VULCAN ONSHORE TIPS

Hydraulic Cylinder Type Packing Upgrade

Vulcan #1 and #0 Series Hammers

(#1, 06, 306, 506, 08, 010, 012, 508, 510, 512 Hammers)

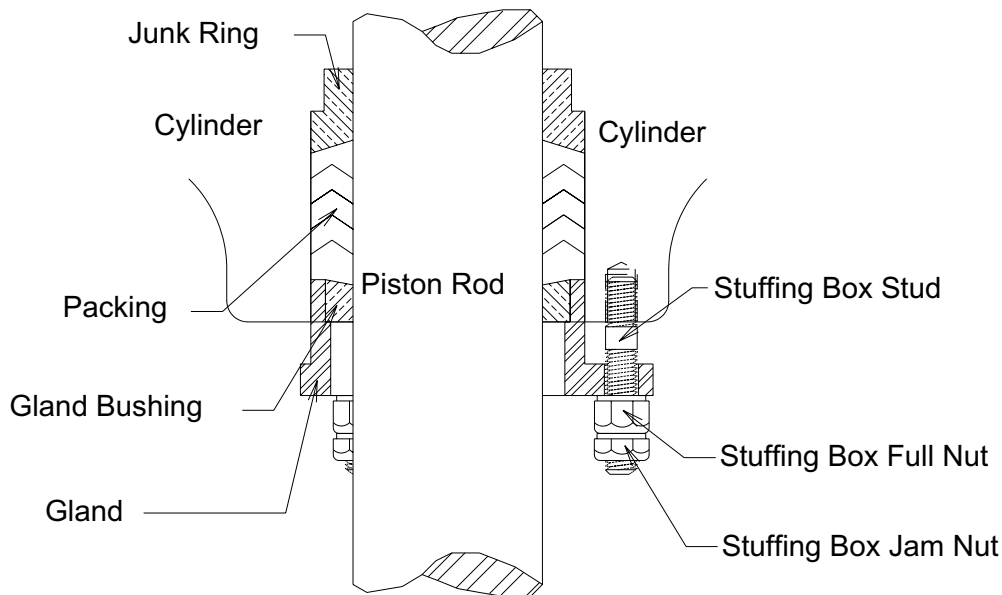
For many years Vulcan hammers have used woven packing to seal around the piston rod. Although this type of packing has performed well, packing with longer life would obviously be better for hammer users.

Vulcan now offers a packing that uses a chevron type packing, similar to rod packing used in hydraulic cylinders. This packing can be inserted into Vulcan hammers without modifying the hammers, providing the gland area of the cylinder is to original factory specifications.

This upgrade is available for Vulcan #1 series Hammers (#1, 06, 306 and 506 hammers, P/N 35366) or Vulcan #0 series hammers (#0, 0R, 08, 010, 012, 508, 510 and 512 hammers, P/N 6214C). This upgrade will work on Raymond and Conmaco hammers with the same cylinder packing gland as Vulcan's.
